Project Name: PEARL JUNIOR HIGH MULTIPURPOSE  
Project No: 22-056

## ADDENDUM NO. 04

**1 OVERALL LIFE SAFETY PLAN - EXISTING BASEMENT**  
1/16" = 1'-0"

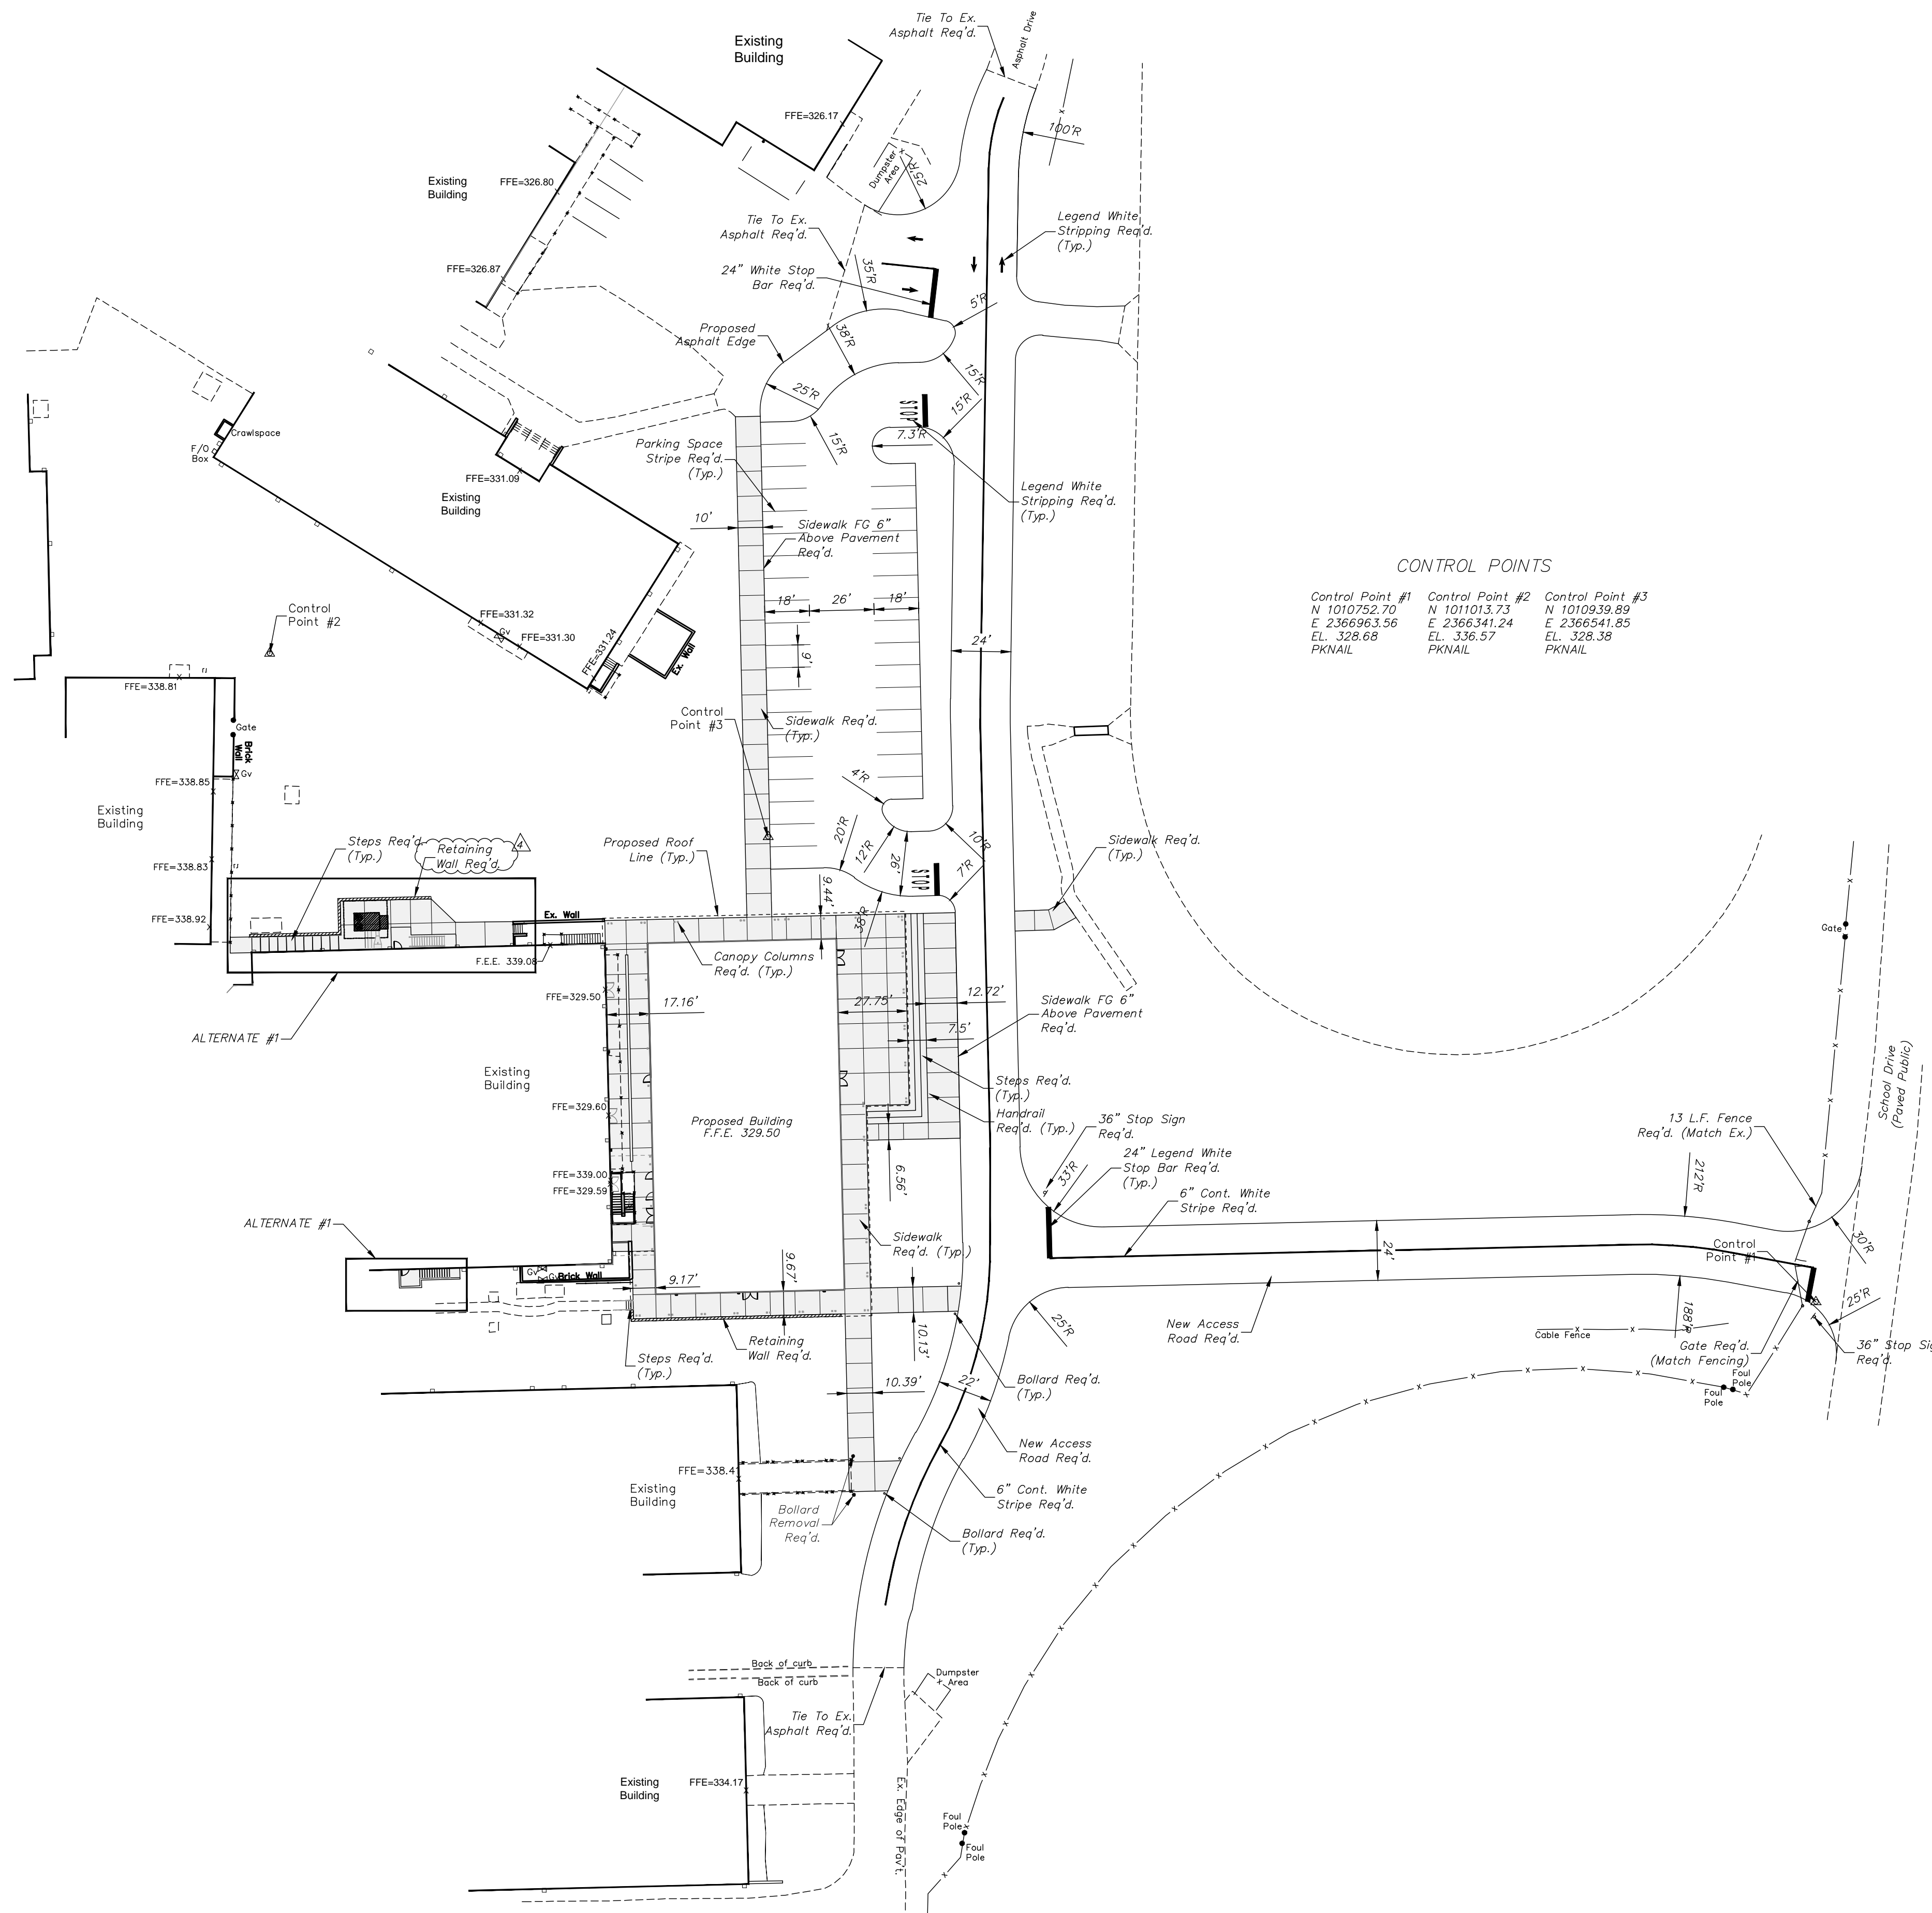
| R200 | LIFE SAFETY COMPLIANCE     | <ul style="list-style-type: none"><li>• Located fire extinguishers.</li></ul>   |

**C201**  
 SITE PLAN

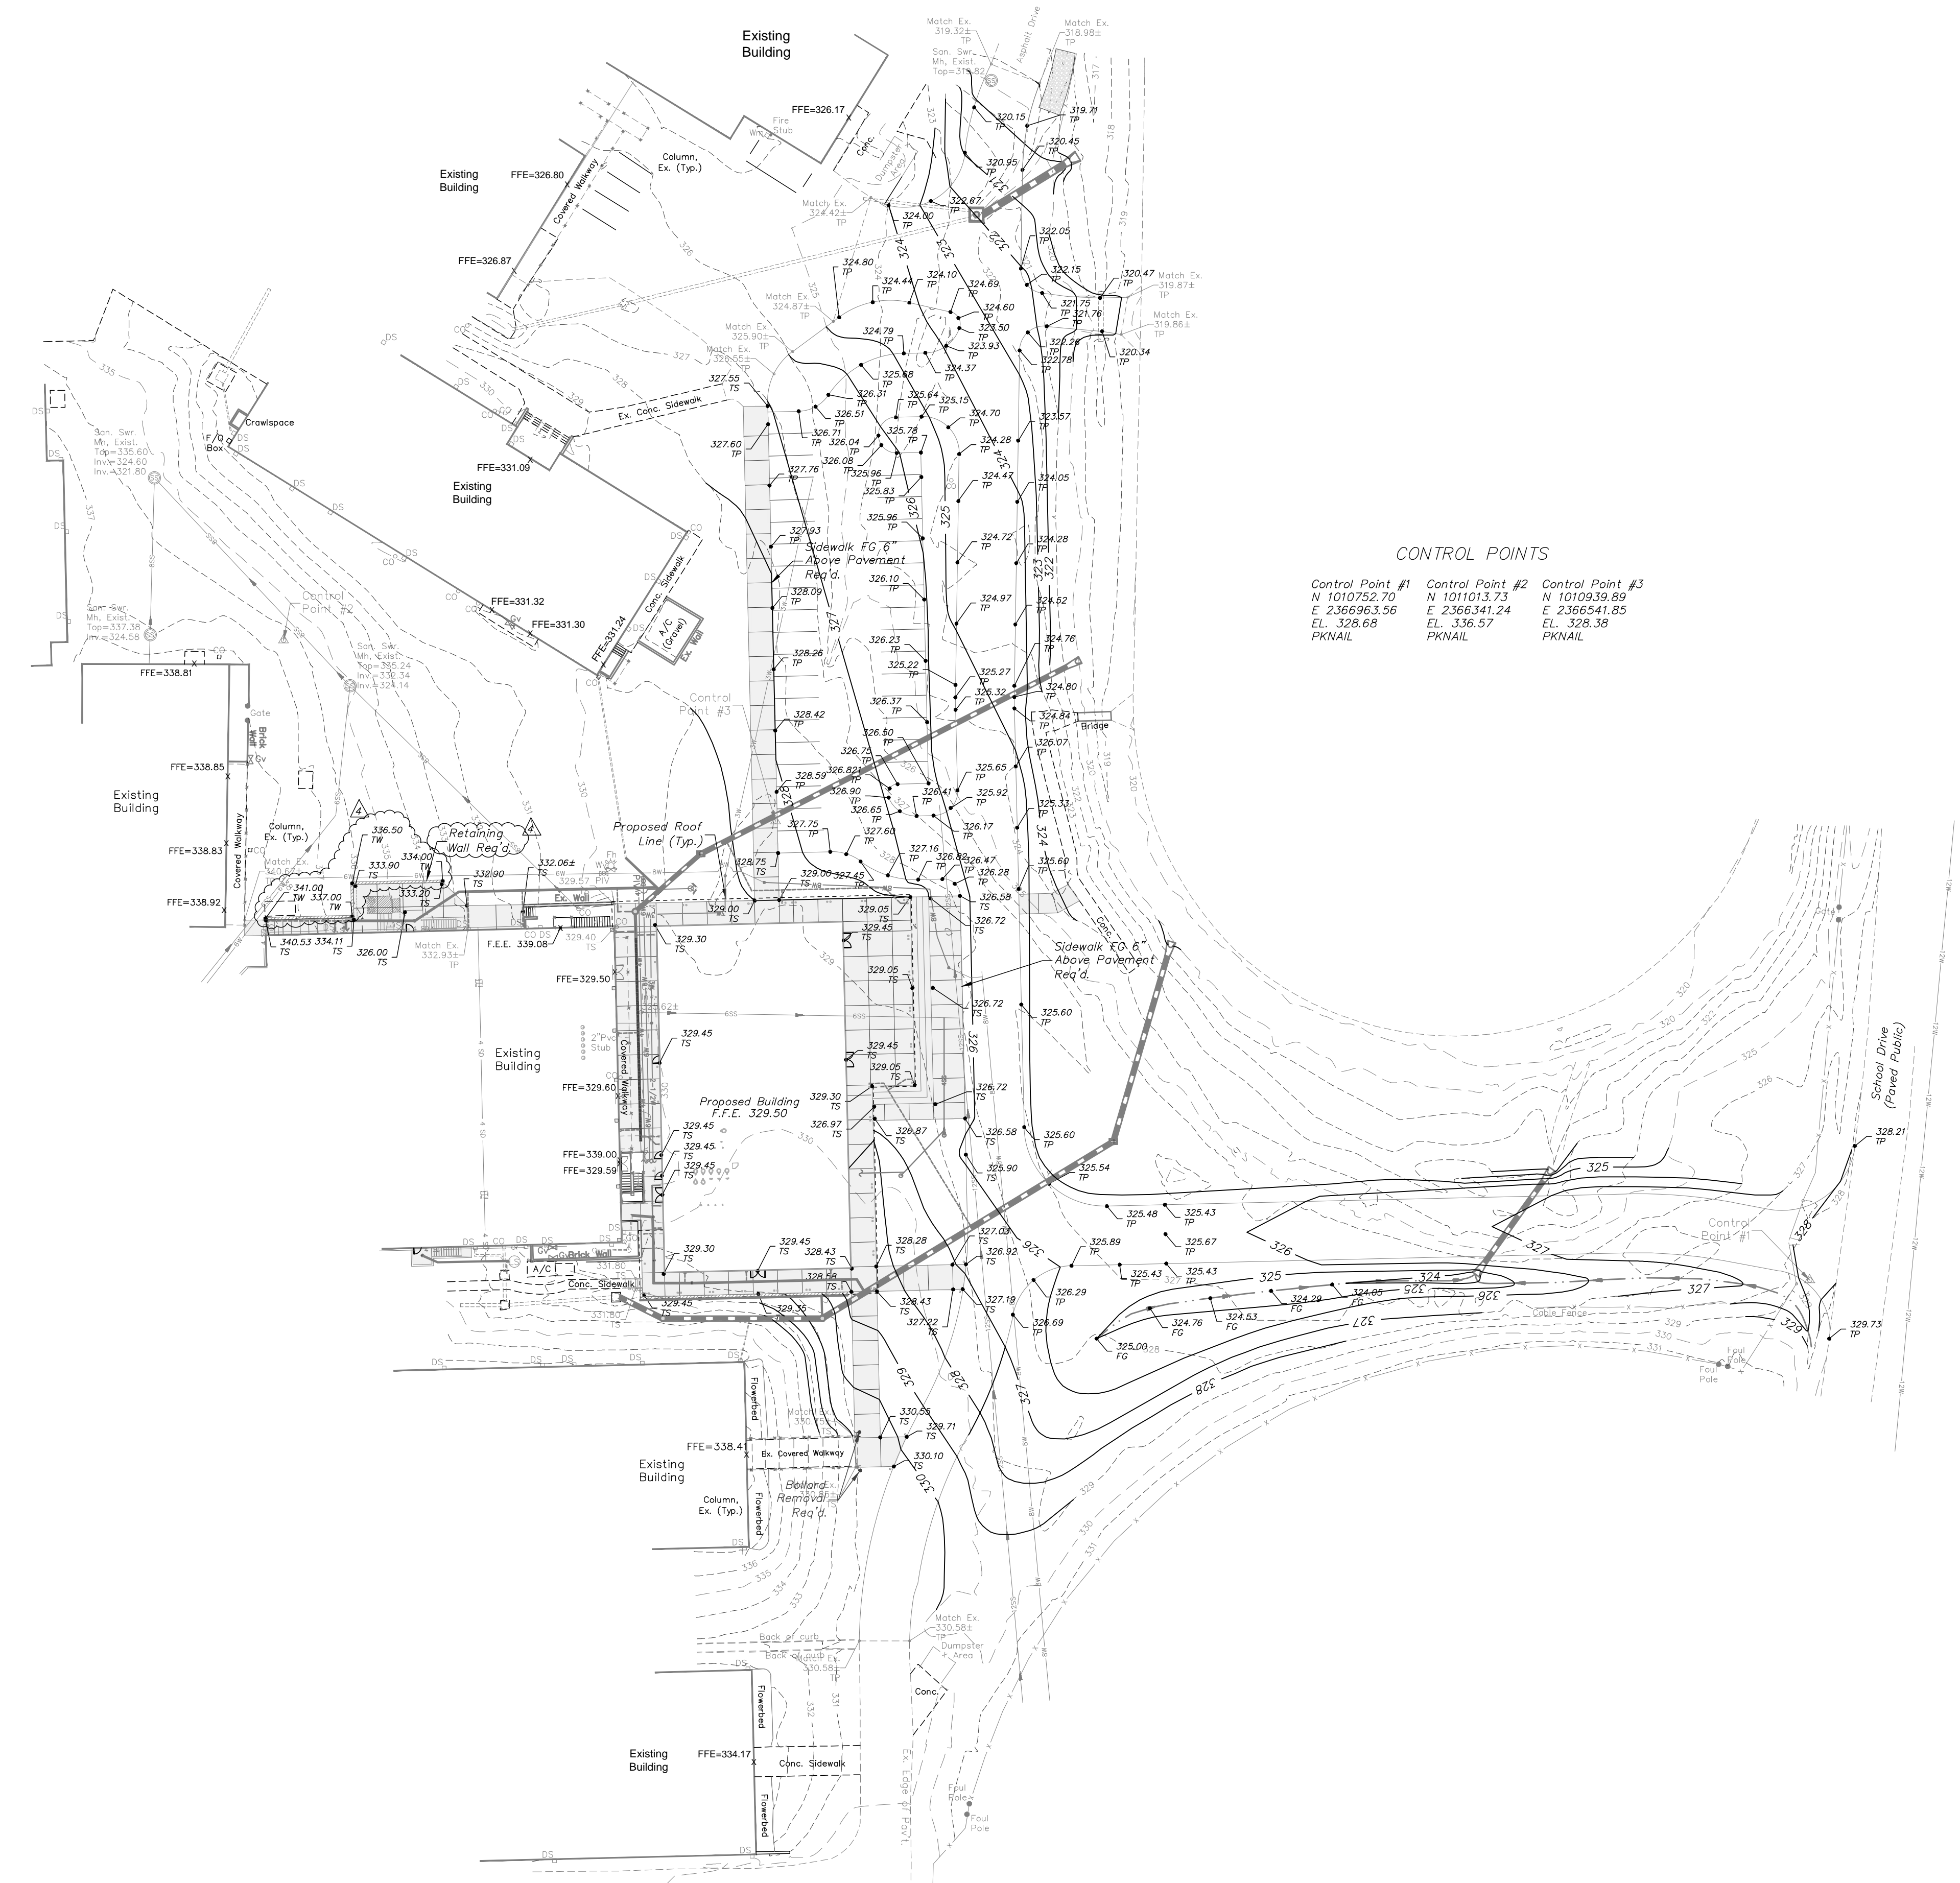
| C201 | SITE PLAN                  | <ul style="list-style-type: none"><li>• Clarification of retaining wall and sidewalk scope of work on the north side of the existing building</li></ul> |

1 GRADING PLAN  
 1" = 40'-0"

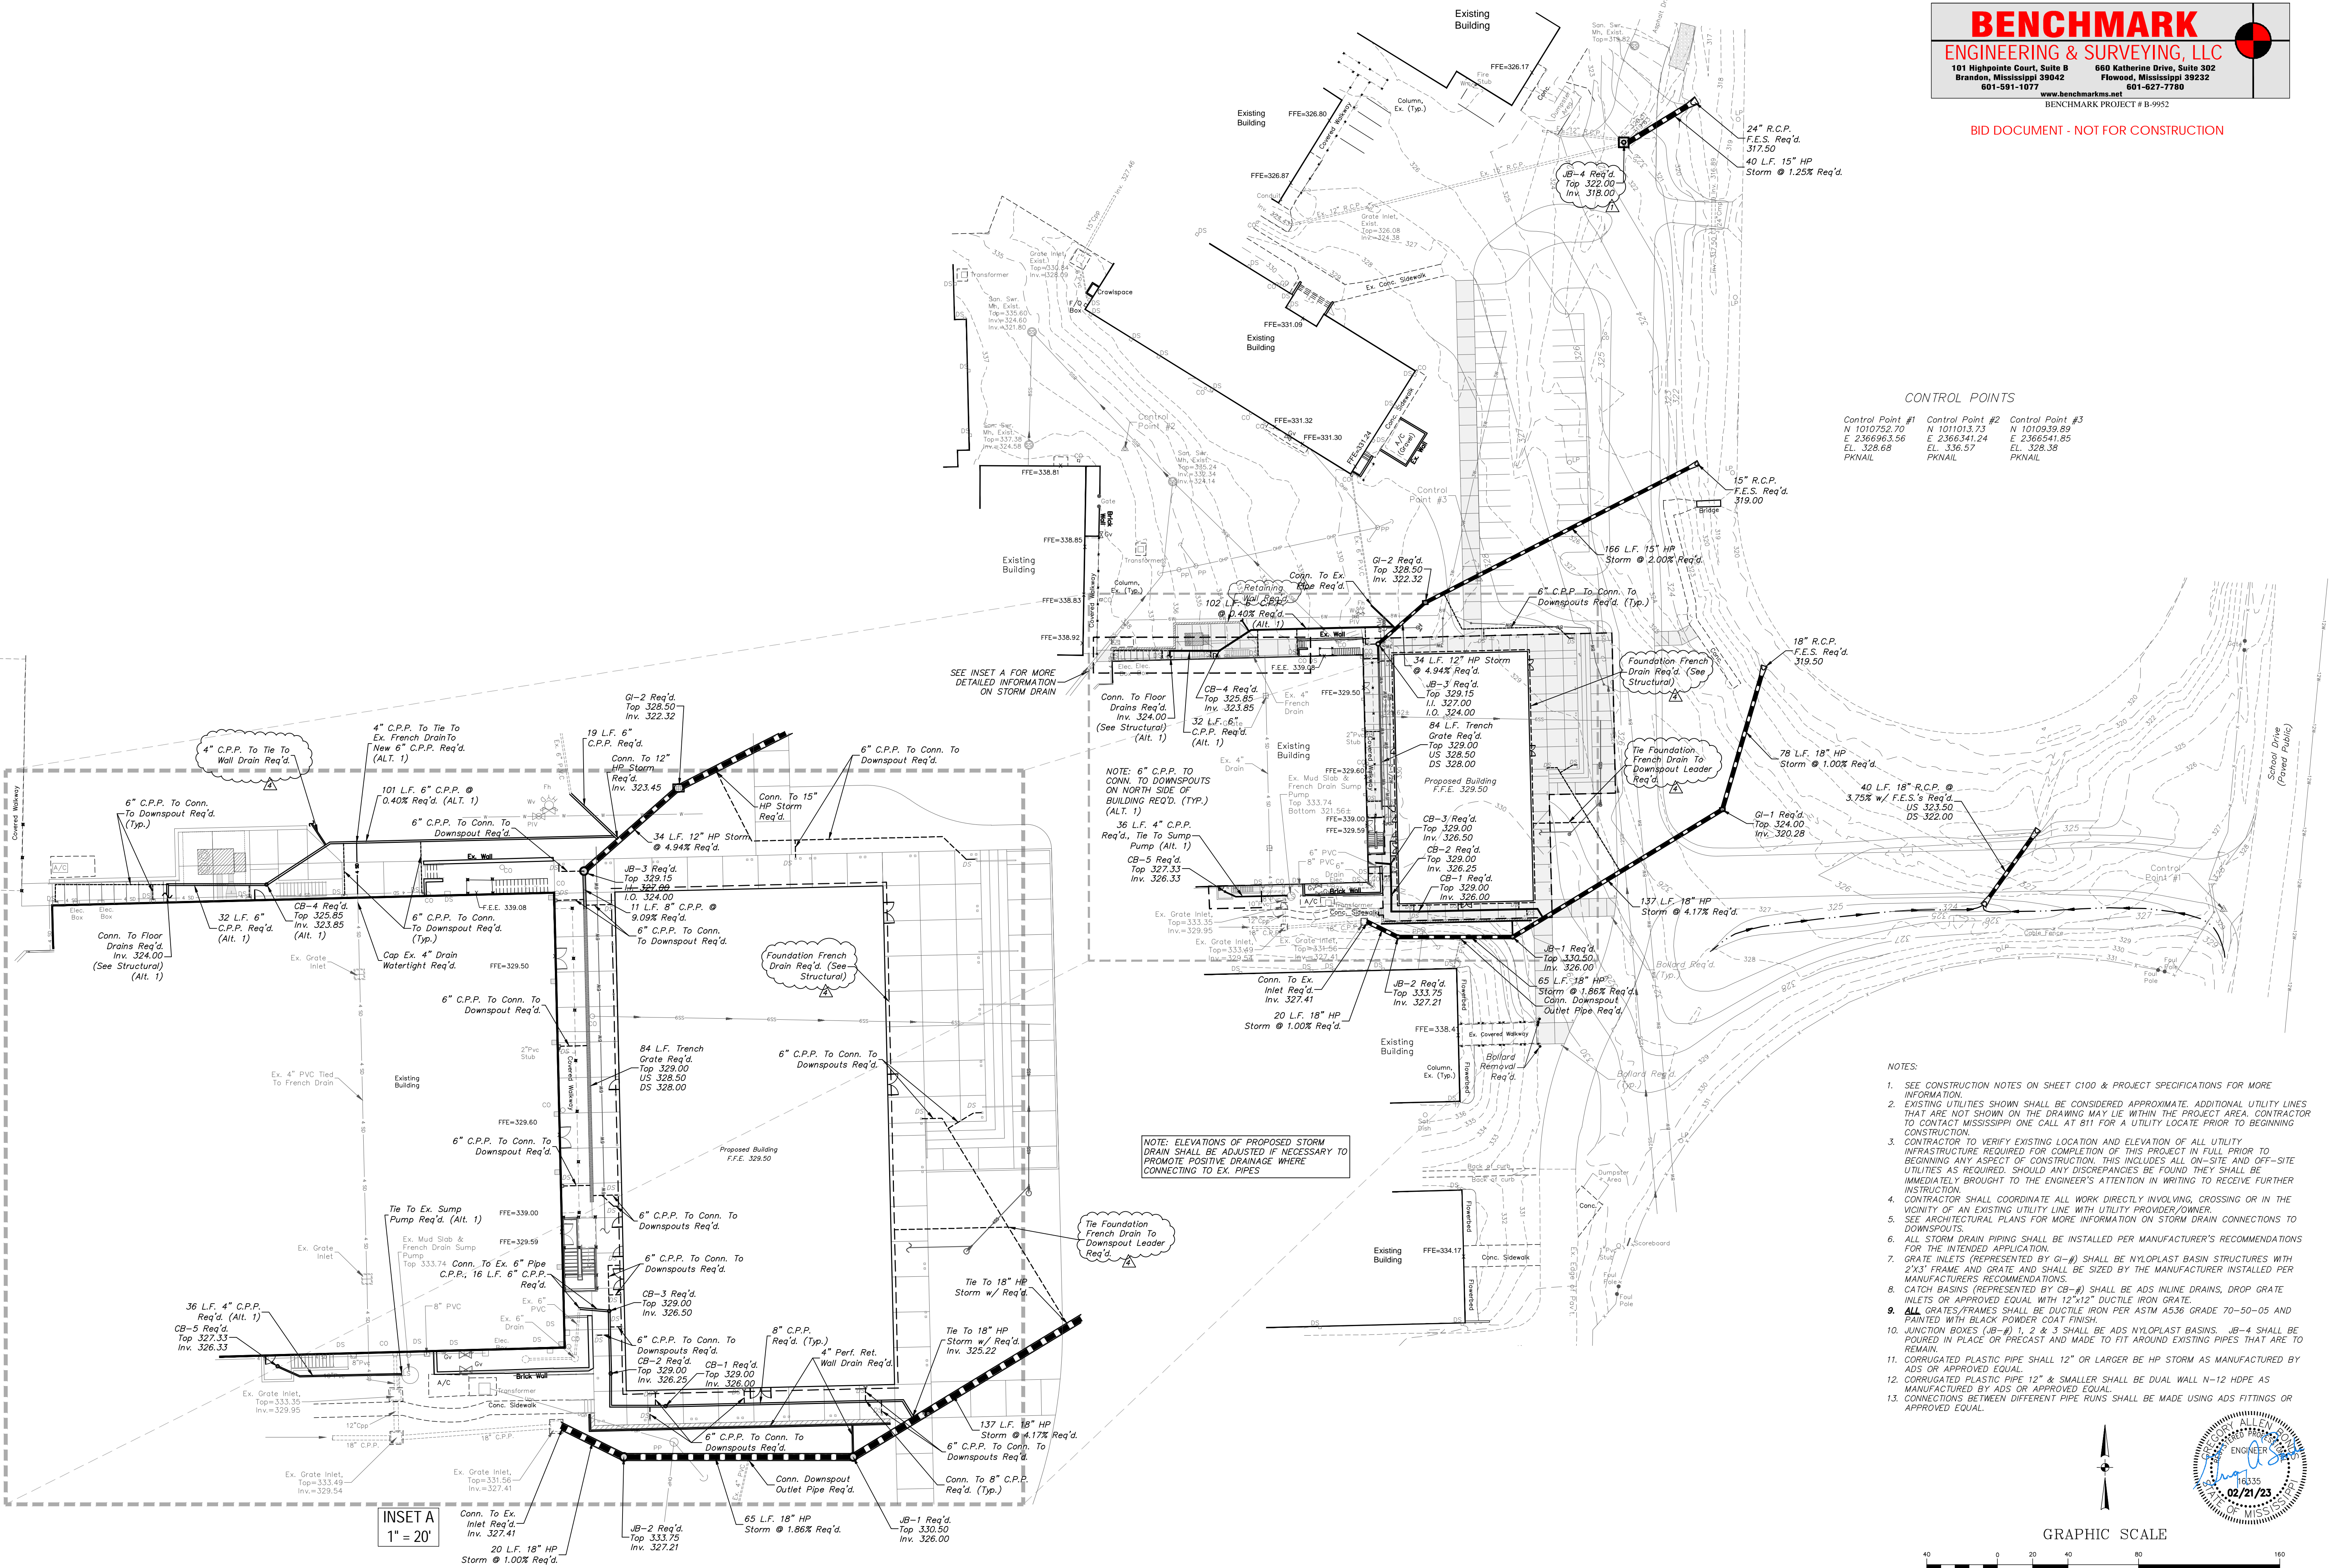
| C301 | GRADING PLAN               | <ul style="list-style-type: none"><li>• Clarification of retaining wall and sidewalk scope of work on the north side of the existing building</li></ul> |
